233 GEARY STREET

HISTORIC PRESERVATION COMMITTEE
PROJECT REVIEW PRESENTATION

RESPONSE TO ARCHITECTURAL REVIEW COMMITTEE COMMENTS

Historic I. Magnin Powder Room

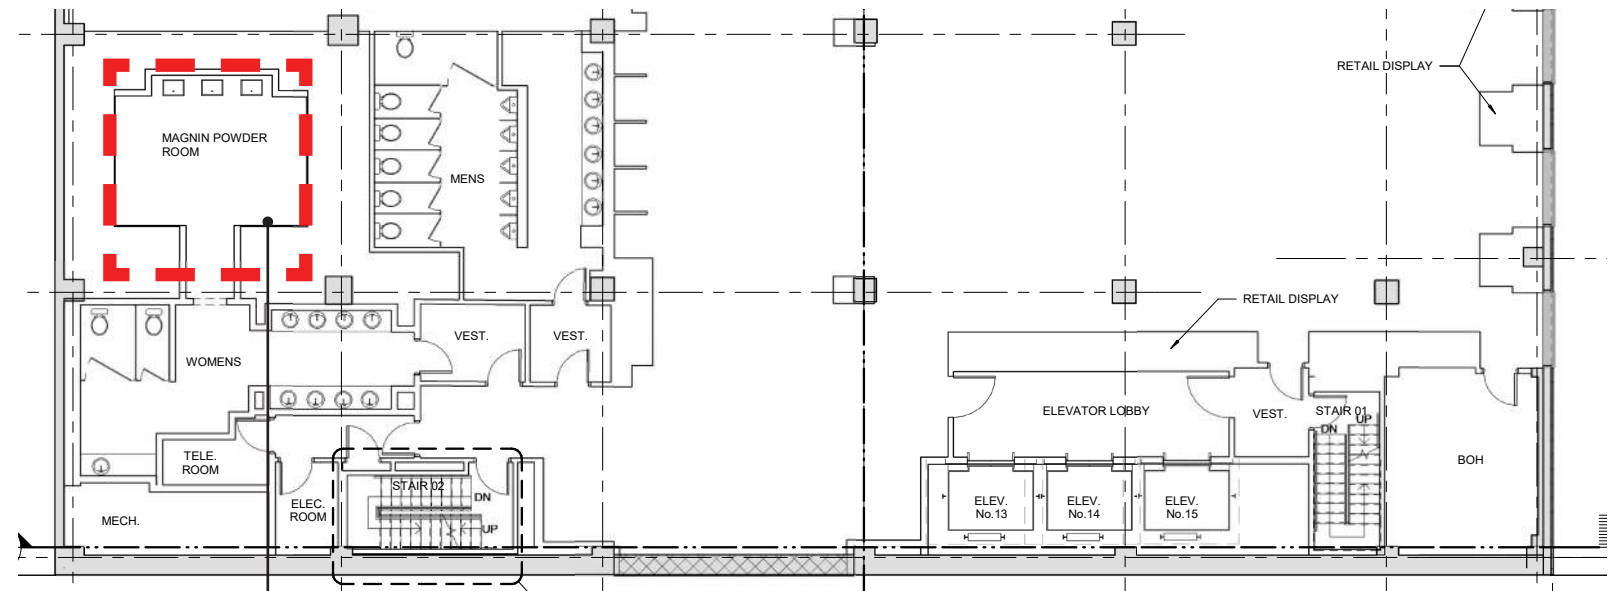
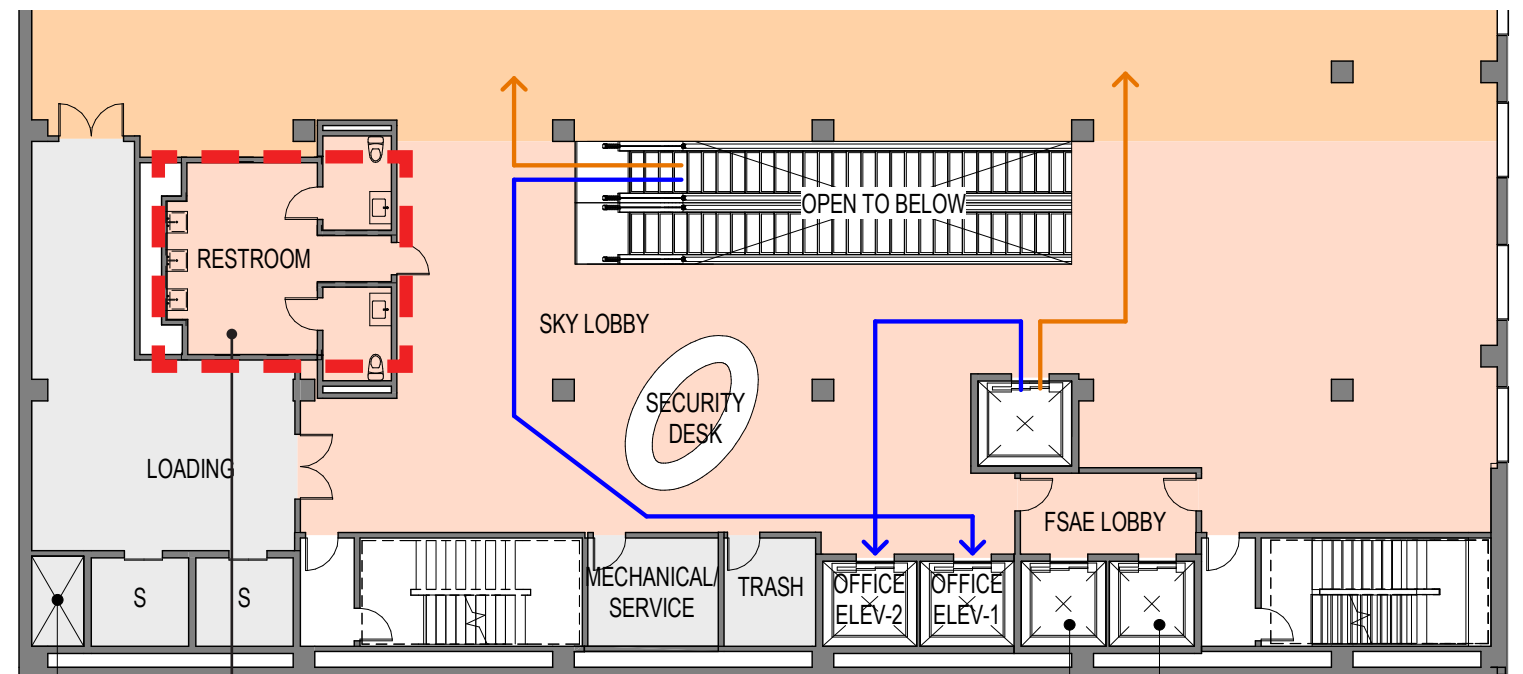
- Existing historic powder room at Level 06
- Ground Floor retail facade materiality and coloration
- Residential window materiality, coloration and detailing

Proposed Location
Historic washroom to be relocated from 6th floor office, to 3rd floor retail/ lobby to allow for better public accessibility and opportunity for interpretive display.

UPDATED SCHEME - BASED ON SF ARC COMMENTS

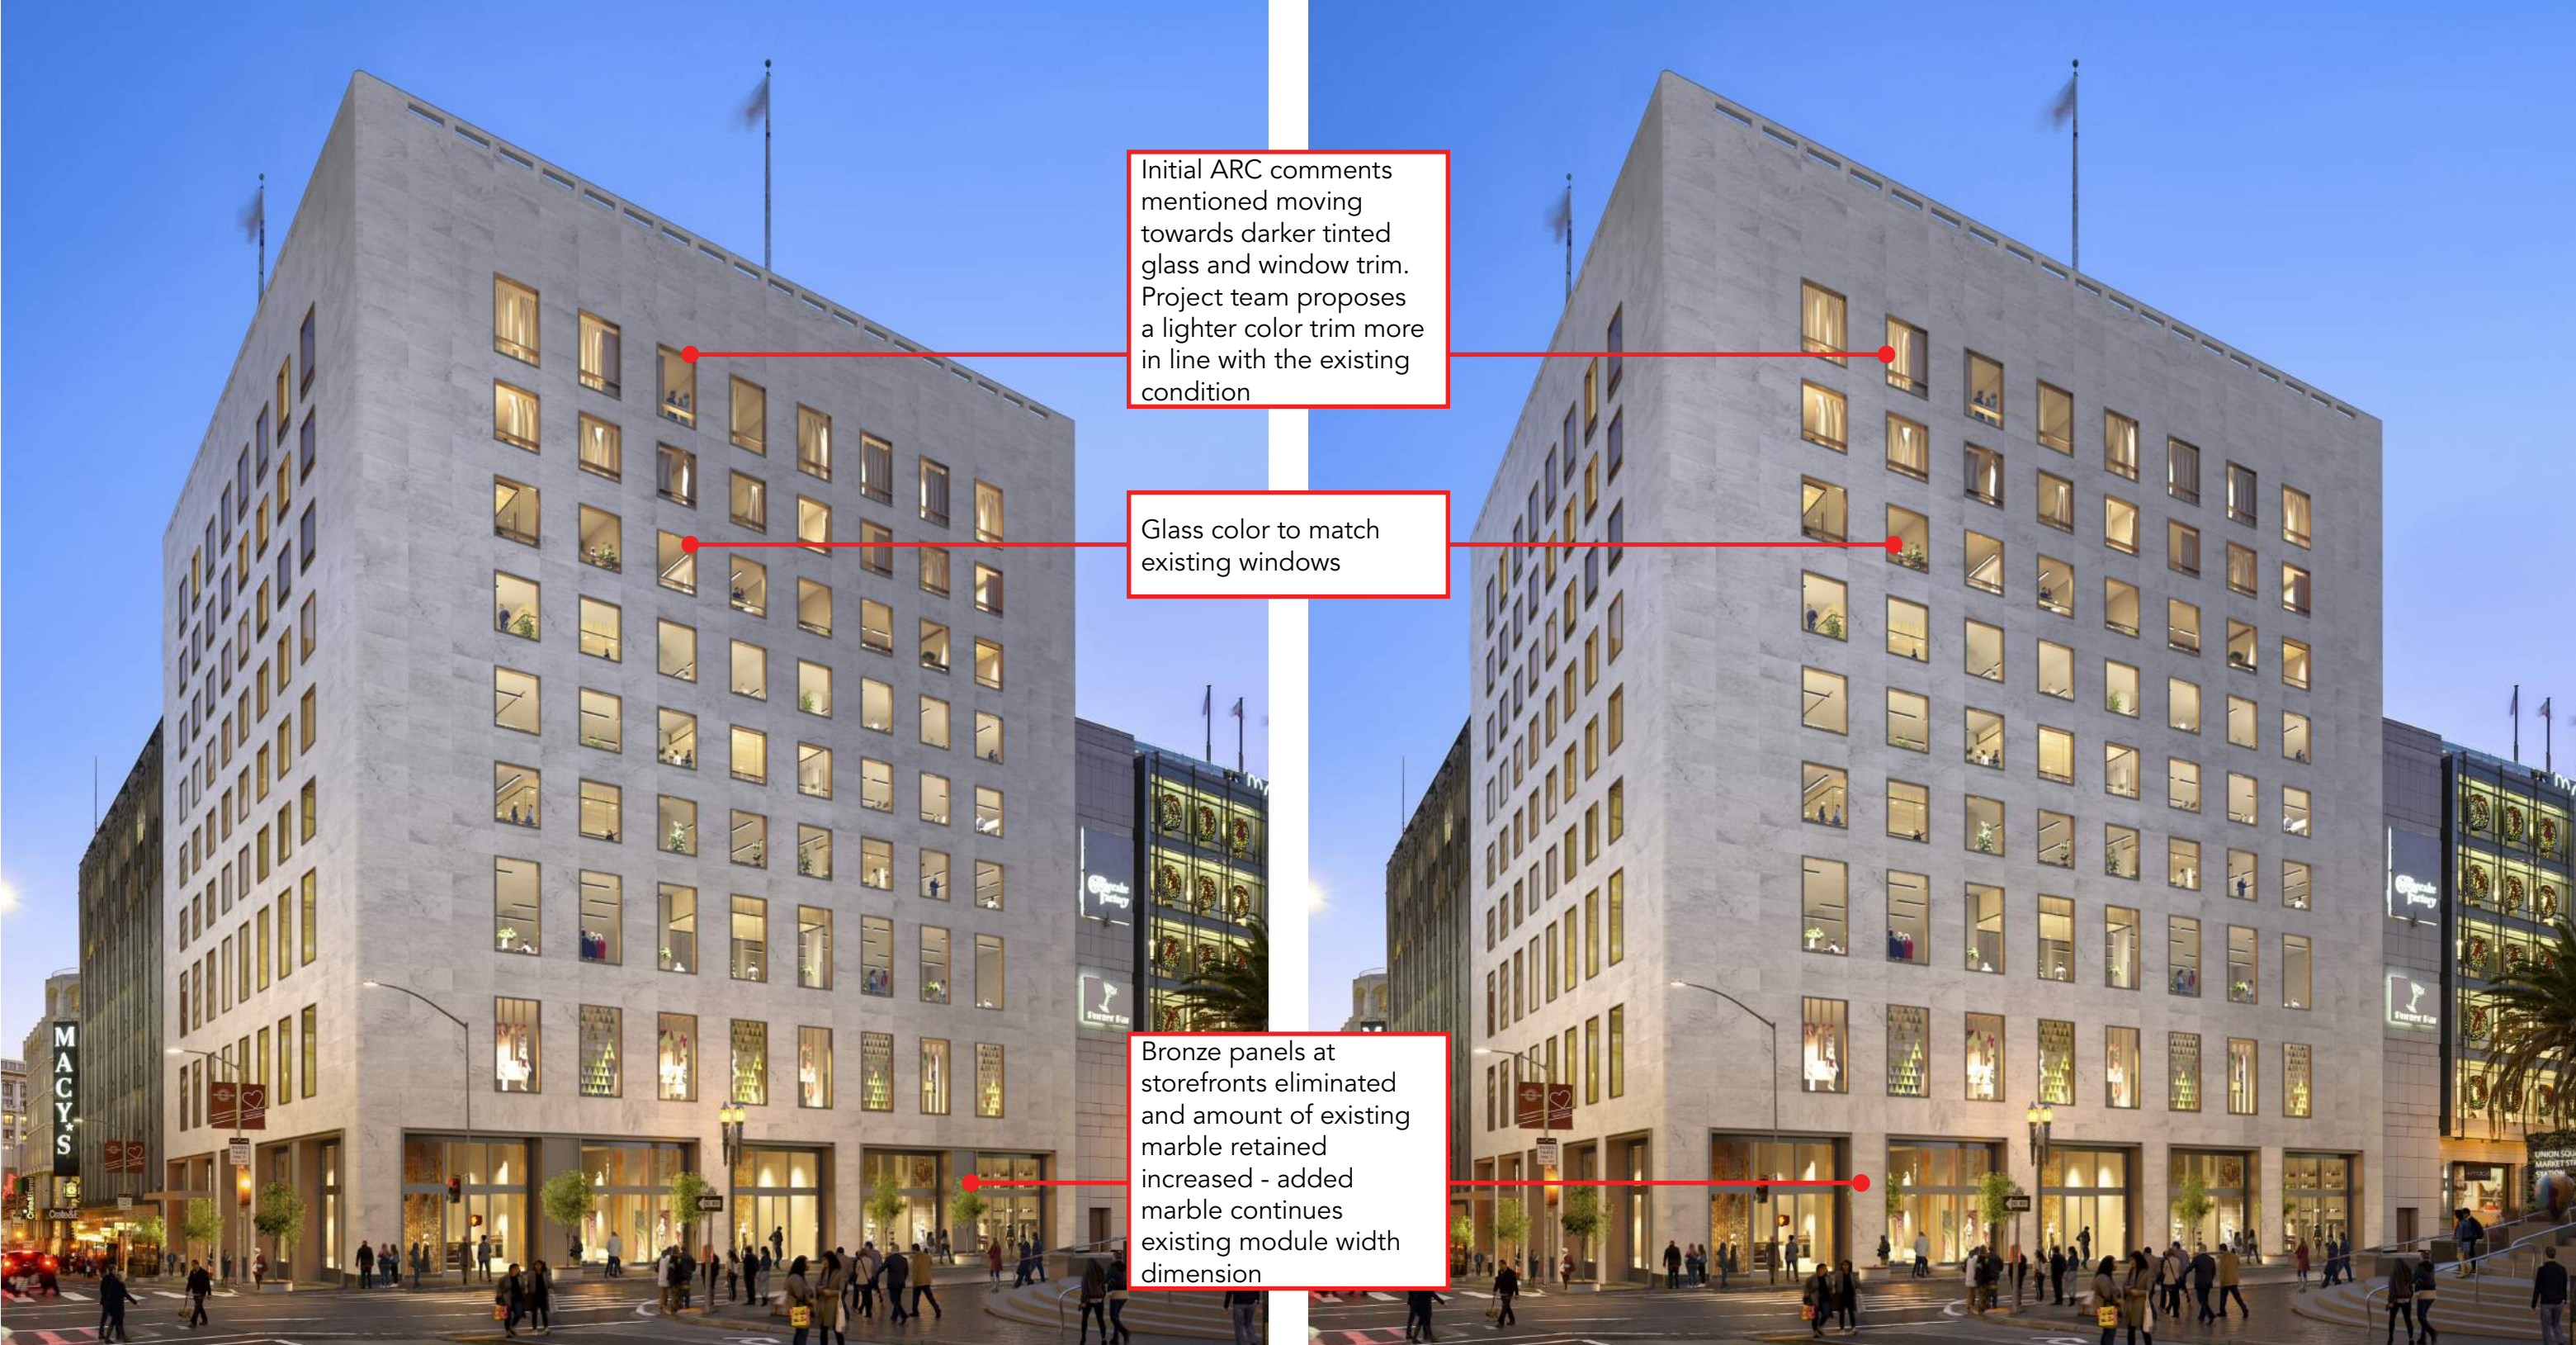
Key items discussed with ARC on May 19, 2021 include:

Bronze panels at storefronts eliminated and amount of existing marble retained increased - added marble matches existing module width dimension

Proposed bronze material re-introduced based on historic precedent. Refer to historic photographs on p. 7.

Bronze panels at storefronts eliminated and amount of existing marble retained increased - added marble matches existing module width dimension

UPDATED SCHEME - BASED ON SF ARC COMMENTS

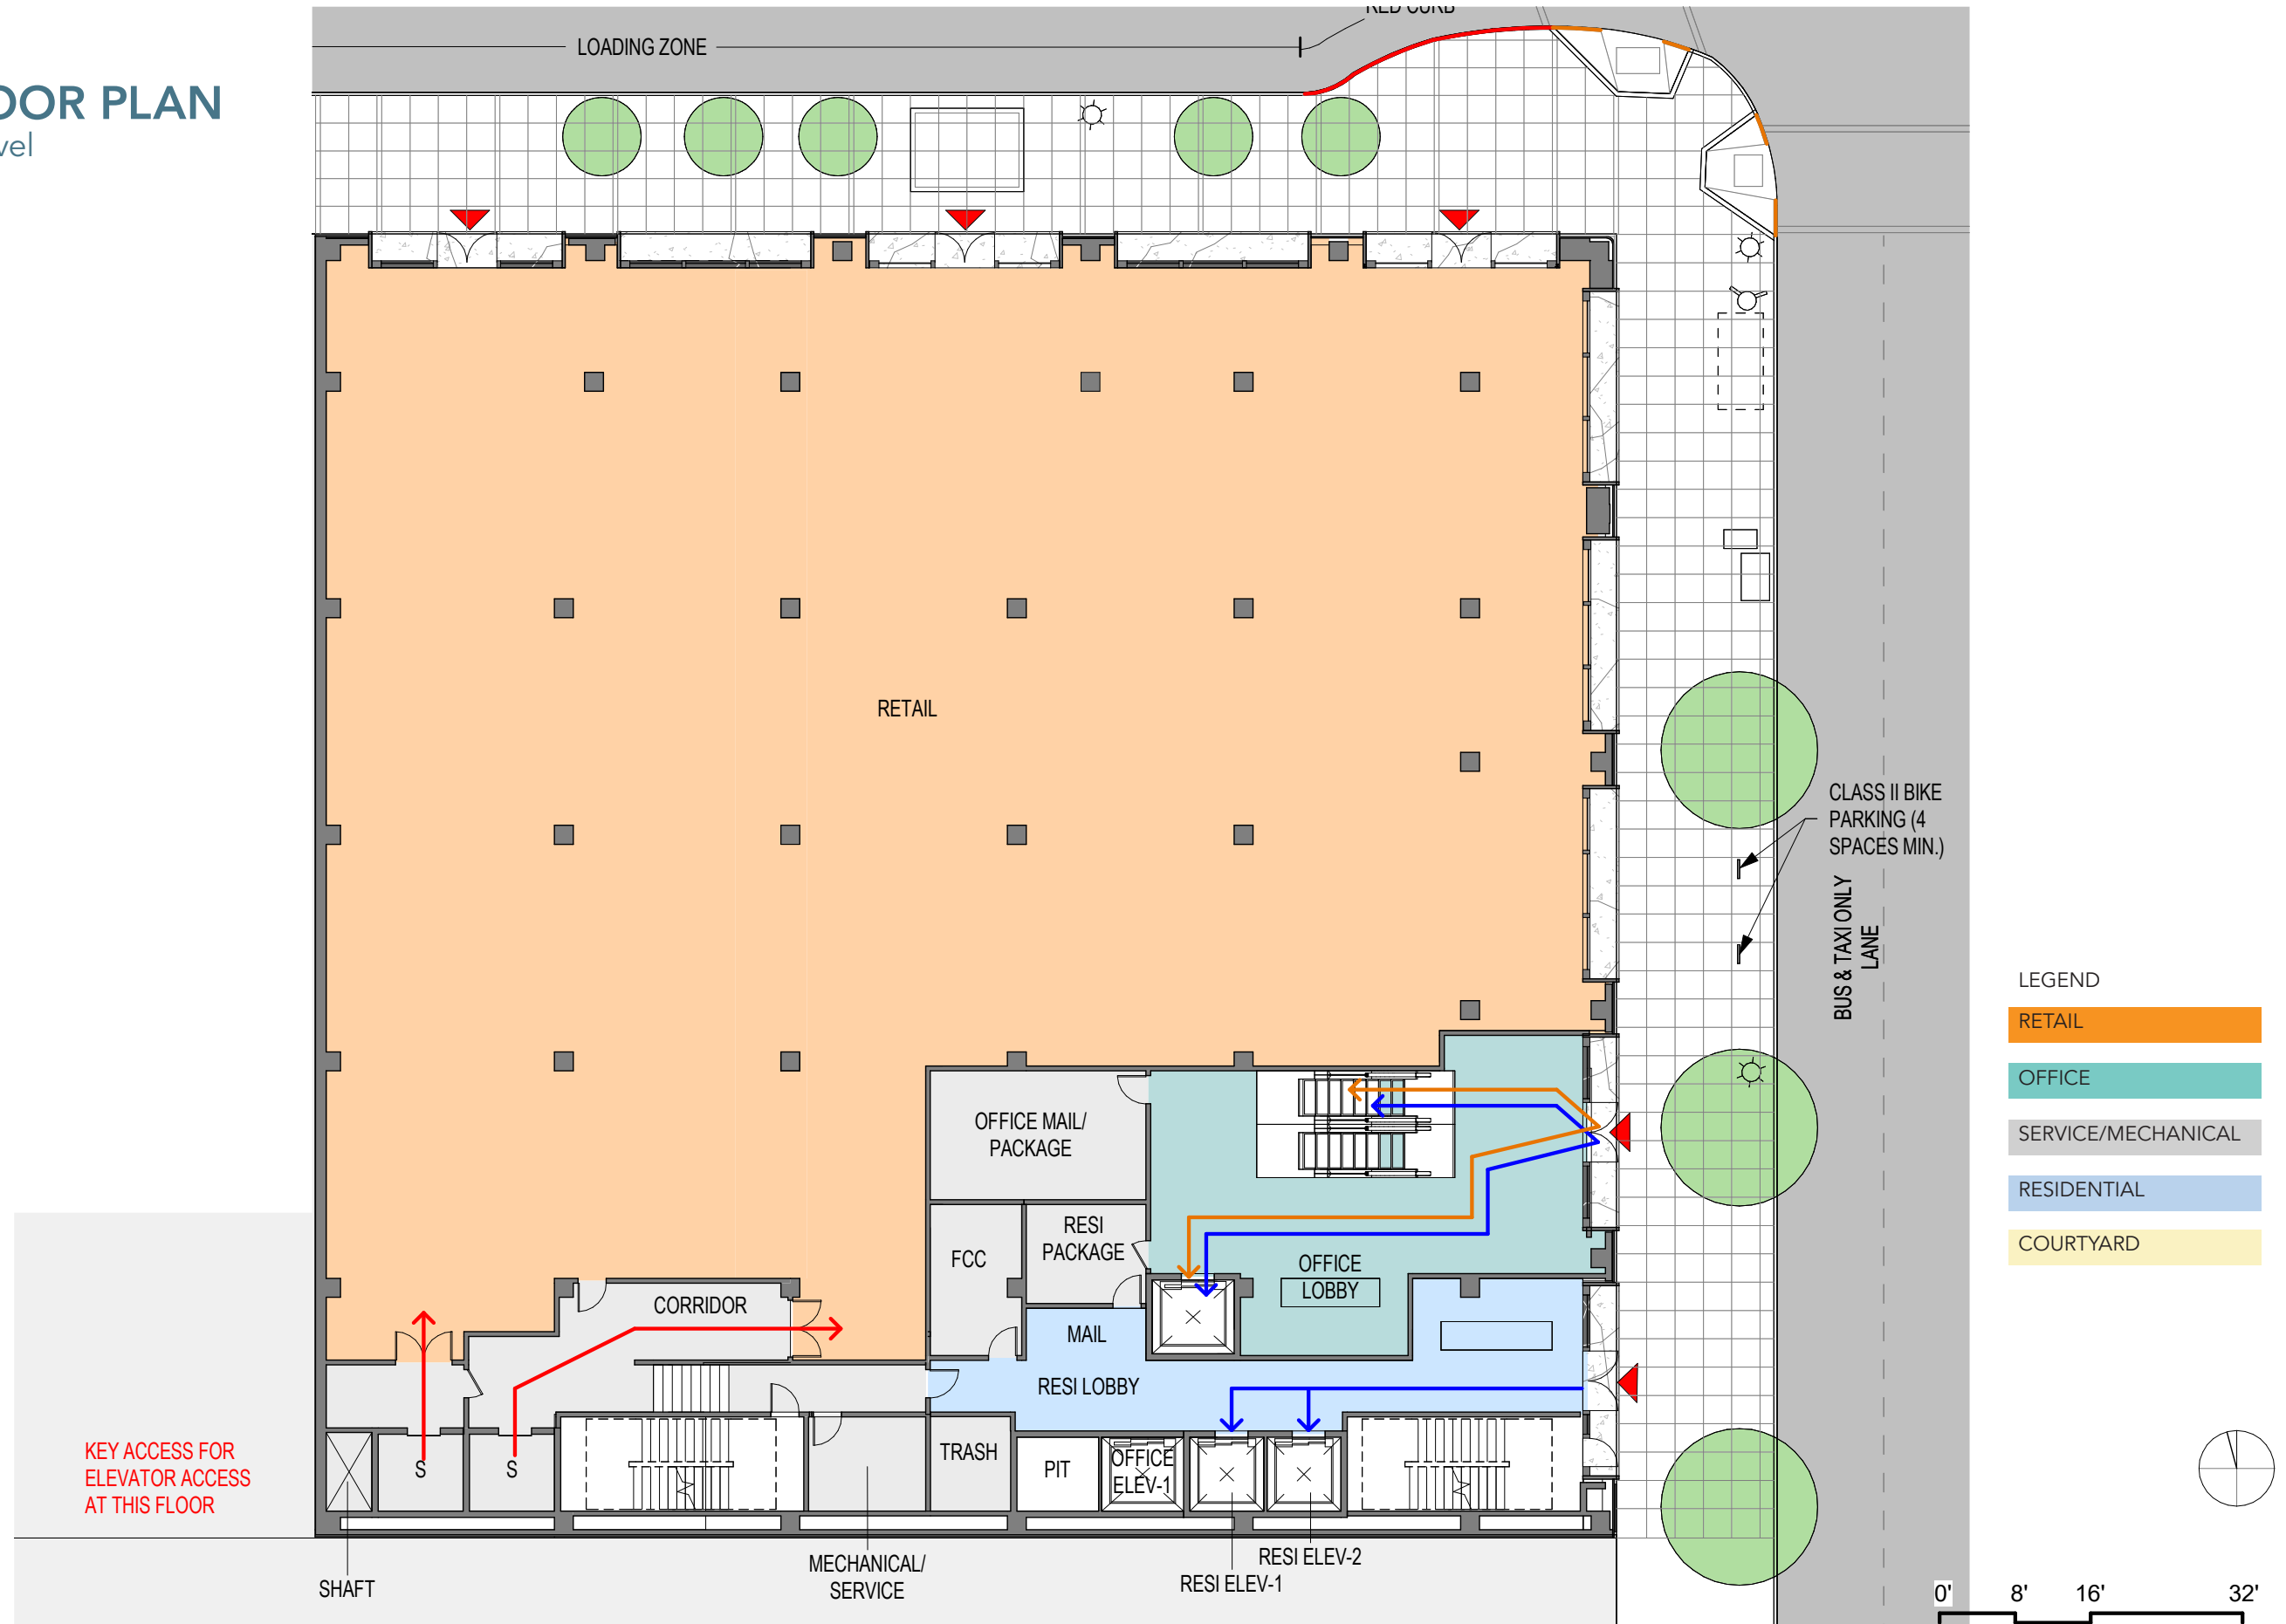
Initial ARC comments mentioned moving towards darker tinted glass and window trim. Project team proposes a lighter color trim more in line with the existing condition

Glass color to match existing windows

Bronze panels at storefronts eliminated and amount of existing marble retained increased - added marble continues existing module width dimension
